City of Portland, Maine - Building or Use Permit Application 389 Congress Street, 04101, Tel: (207) 874-8703, FAX: 874-8716

| ADDRESS: 286 Bracket St DATE: 6/9/99 | |
|--|-----|
| REASON FOR PERMIT: rebuild Deck | |

| | BUILDING PERMIT REPORT |
| REAS | ON FOR PERMIT: Re. Construct 201/2 X8' deck Lower dock 41/2 441/2 |

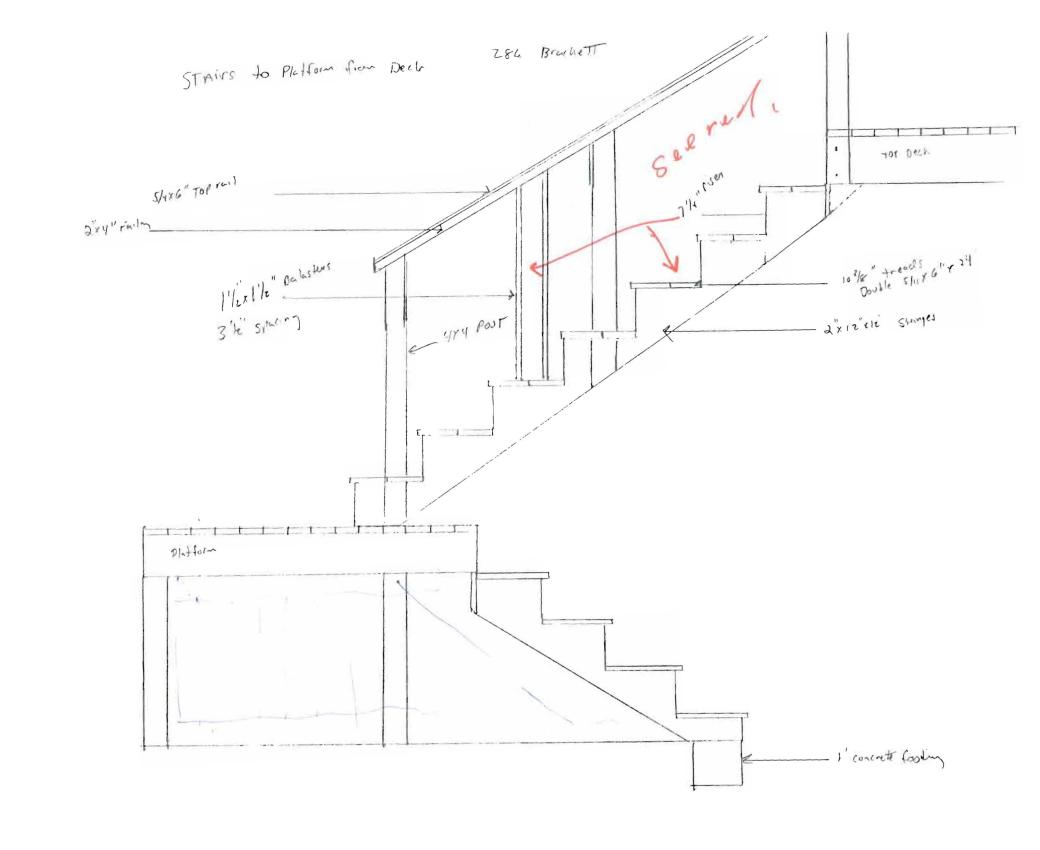
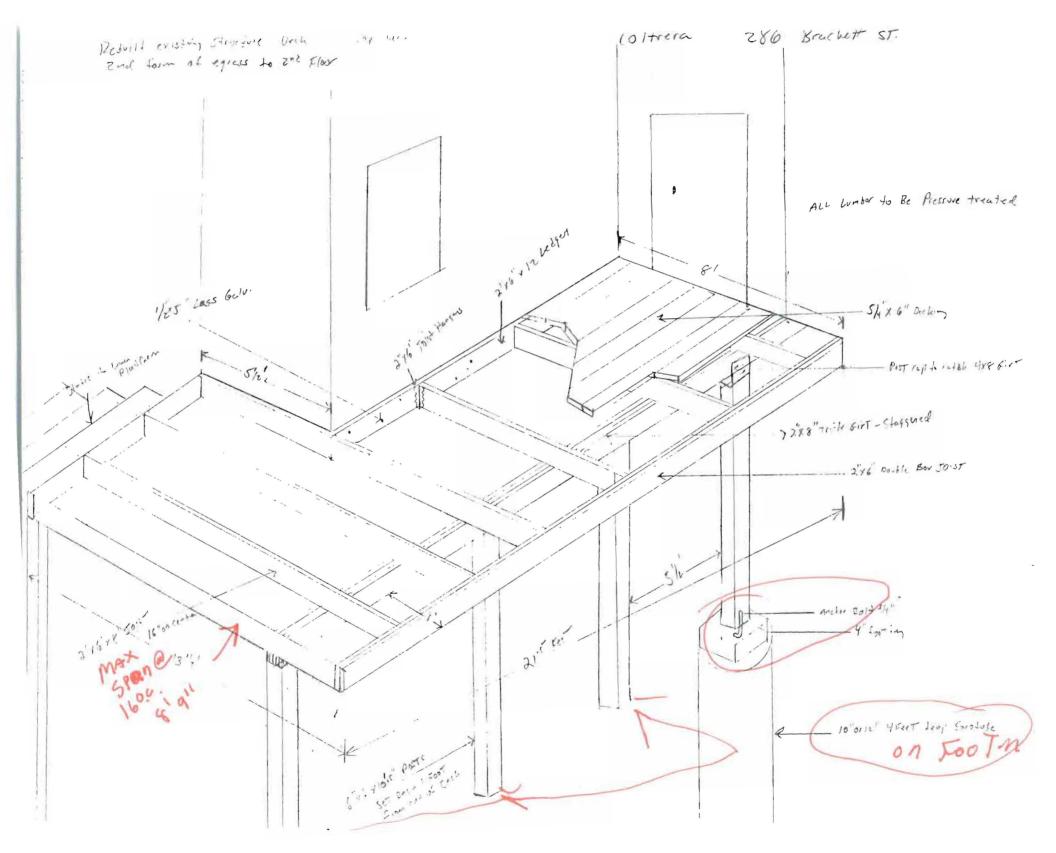
- Proposed piers (5000 Tubes 10") Shall be placed on Footing with anchor between pier

The proposed Ledger attached To dwelling shall be Lagged To bailding

SKETCH PLAN OF LAND **PORTLAND** MAINE

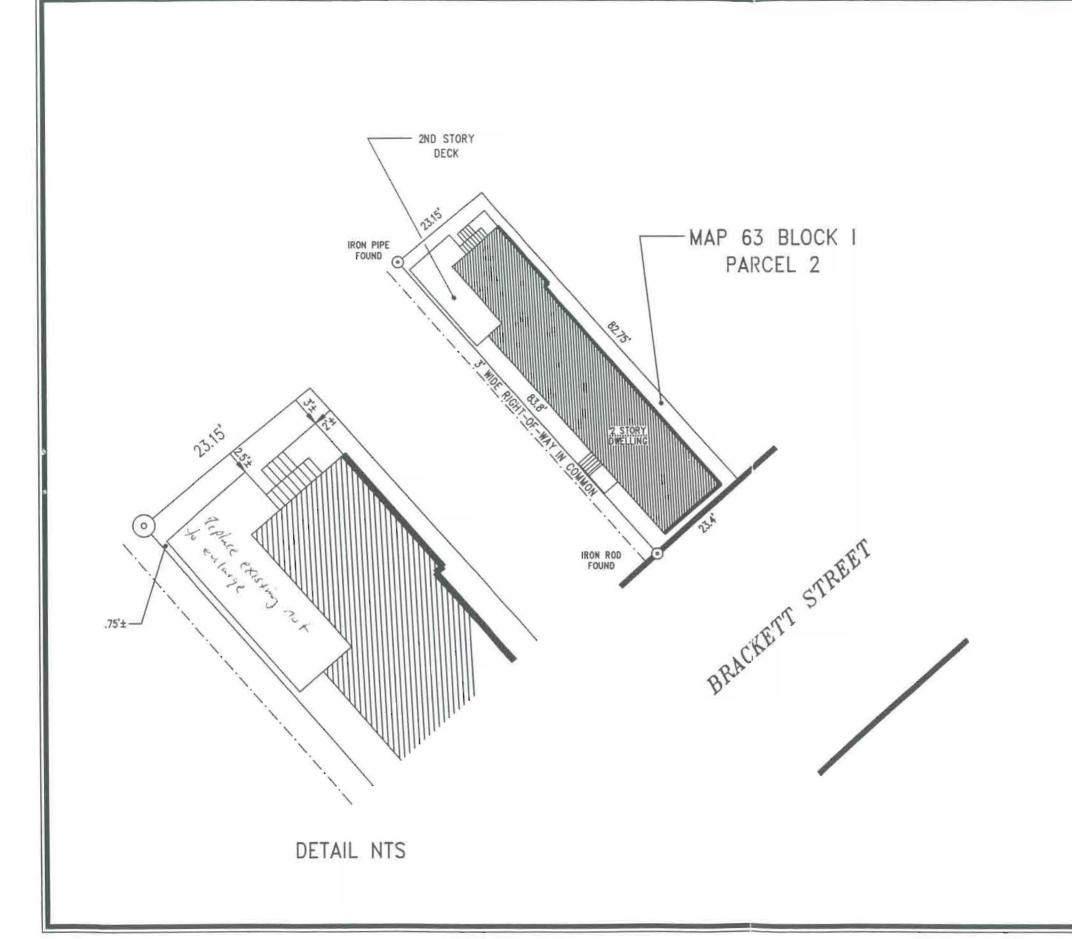
^{**}On the basis of plans submitted and conditions placed on these plans any deviations shall require a separate approval.
